ASSESSMENT REPORT

Shoalhaven Starches Ethanol Expansion Project Relocation of Starch Dryer No. 5 Section 75W Modification - MP 06 0228 MOD 7

Figure 3 – Elevation of starch dryer compared to existing factory buildings

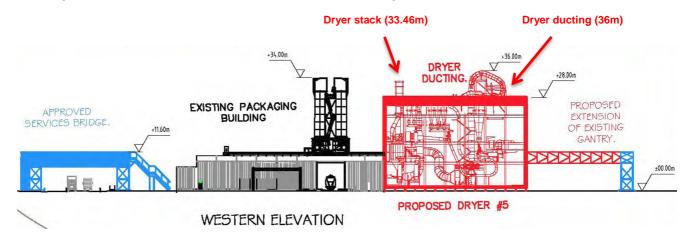
The dryer would cover an area of 50 metres (m) by 60m and have a height above ground level of 28m. A dryer stack would extend above the roof to a total height of 33.46m and dryer ducting would extend above the roof to a total height of 36m (see **Figure 3**). The dryer building would be constructed of Colorbond metal cladding.

Visual amenity and building height	 Visual Amenity The starch dryer would be 28m above ground level with the stack extending to 33.4m and the dryer ducting to a height of 36m. The starch dryer would be most visually prominent to passing traffic and pedestrians on Bolong Road as it is located 45m from the roadway. Many of the existing factory buildings and processing equipment are also located adjacent to Bolong Road, including the interim packing plant at 34m high. The proposed starch dryer would be consistent in size, scale and colour with these structures. The starch dryer would also be partially visible from the residences on the southern side of the Shoalhaven River around 750m from the site. However there are other intervening structures of similar height (DDG pelletiser plant at 29m and stack at 49m) and vegetation that would partially screen the starch dryer from this viewpoint. Council did not raise any concerns regarding visual amenity and recommended the use of non-reflective building materials. The Department's assessment concludes that the visual impacts of the proposed modification would be minimal given the scale of the existing industrial development on the site and that the additional structures would generally be of a similar appearance, height and bulk to the existing structures on the site. The Department considers that the visual impacts of the modification would be minor and would not require any specific conditions beyond the control of lighting, use of non-reflective building materials and landscaping requirements of the existing approval. Tall Structures HMAS Albatross (airbase) is located 10km south-west of the factory. The Proponent provided information to the Department of Defence regarding the height of the starch dryer (36m) and associated stack (33.5m). The Department of Defence considered the potential impacts to the safety of aircraft operations from HMAS Albatross and advised that it had no concerns with the modification and	The Proponent shall provide asconstructed details to Airservices Australia following completion of construction of the starch dryer; and If any LED obstruction lighting is to be installed on tall structures on the site, the frequency range of the LED light emitted must fall within the range of wavelengths 655 to 930 nanometers, and be installed to the satisfaction of the Department of Defence.

Figure 4 – Relocated Starch Dryer No. 5, Gantry Extension and Sub Station (Inset photo shows the proposed location for the relocated starch dryer)

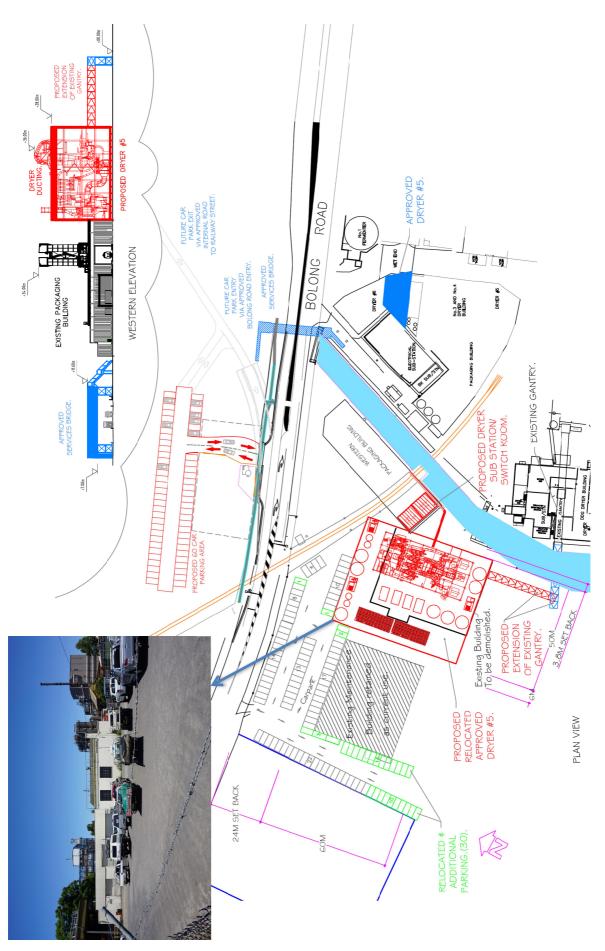
- relocating the starch dryer from the approved location on the eastern side of Abernathy's Creek (see Figure 2) to the western side of Abernathy's creek on the 'Moorehouse' site (see Figure 4);
- increasing the size of the approved starch dryer from 255 square metres (m²) to 3,000m²;
- extending the existing gantry (pipe bridge) to connect to the relocated starch dryer. The
 gantry is located at ground level and is 2.5m high and 1.5m wide. The gantry contains
 pipes for the supply of materials to the dryer including water, liquid starch and power. It
 also contains pipes for the transfer of effluent and waste water back to the factory; and
- a substation to supply power to the starch dryer. The substation would be housed within
 a concrete structure under the existing awning of the adjacent interim packing plant.
